AMENDMENTS TO THE DRAWINGS

ANNOTATED SHEET SHOWING CHANGES

FIG. 8

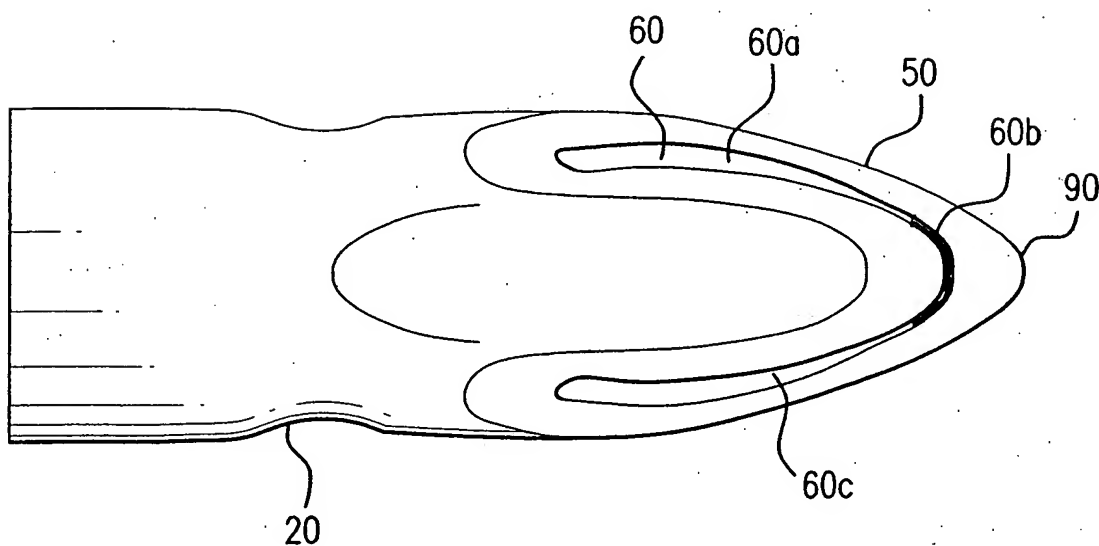
The attached sheet of drawings includes changes to Fig. 8. This sheet, which includes Fig. 7-8, replaces original sheet including Fig. 7-8. In Figure 8, the section 60b which was shaded in the original drawings was inadvertently not shaded in the formal drawings. This amendment is to add this shading back into Fig. 8.
